### Fire Protection Assessment Report

# TESORO SAVAGE VANCOUVER ENERGY DISTRIBUTION TERMINAL

STATE OF WASHINGTON  
ENERGY FACILITY SITE EVALUATION COUNCIL

August 10, 2015

**FIGURE 3.2 – WATER MAINS AND HYDRANTS, RAILCAR UNLOADING FACILITY**

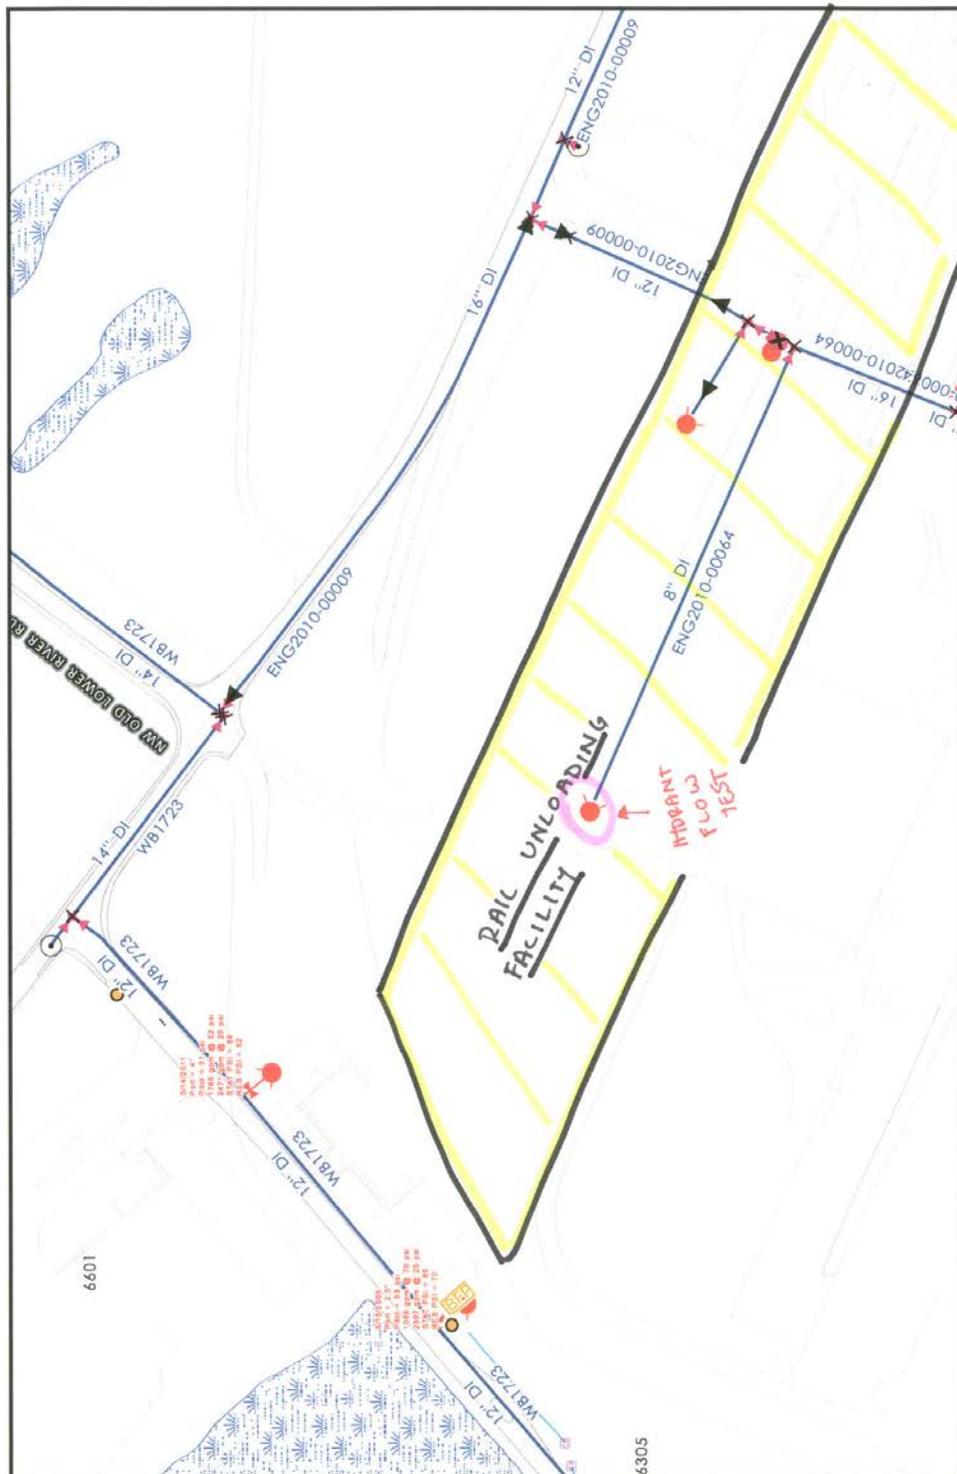
Hydrant locations are marked on Figures 3-2 and 3-3, but these locations are not necessarily confirmed on official maps. It is assumed (subject to verification) that these are all City hydrants, although Port hydrants also exist near these areas. Assuming that the hydrants indicated on these figures are reasonably accurate, there appears to be adequate hydrant coverage for VFD's response needs.

**FIGURE 4.1 – OFFSITE WATER MAINS AND SUPPLY SYSTEM**

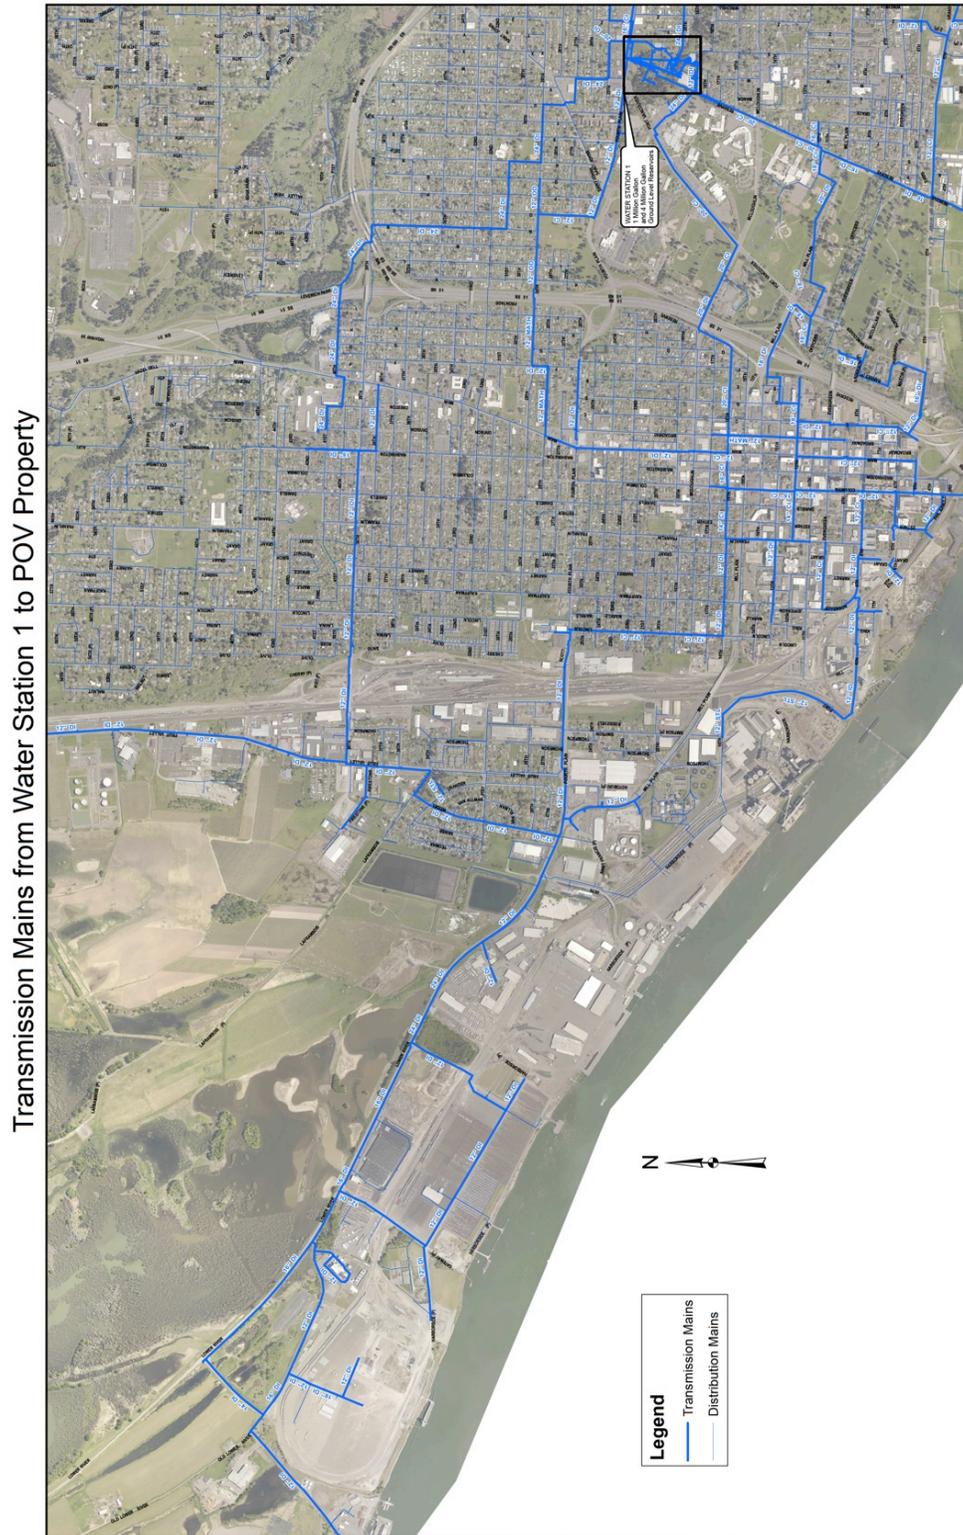
Several weak points in the system were noted. The first weak point in the system is the section of single 12-inch water main along NW Lower River Road which supplies the west Port area. This is a restriction of line size considering the demands of the Port area, and is evidenced by the fact that it increases again to 24-inch further west. This may also explain the somewhat low fire flow rates and pressures measured by the City testing. Note also that the Applicant added fire pumps to increase pressures at the different connection points. It is possible that the 12-inch line size shown on the map is an error and this should be confirmed with the City. It is also possible that the City intends to extend the northern 12-inch main at a later date to connect to the 24-inch or 16-inch main.

The second weak point is that the 12-inch and 24-inch supply mains along NW Lower River Road are dead end routes to the west side of the Port, thus there is no looped supply to provide redundancy in case of a water main failure or leak. Again, this may be resolved by the City at a later date with westward expansion and additional mains.

While these weak points do not necessarily invalidate the City's assertion of reliable 3,500 gpm supply, they do represent areas of concern, and should be considered when determining if auxiliary water supply is needed for the Facility fire system, such as a water pump in the Columbia River.
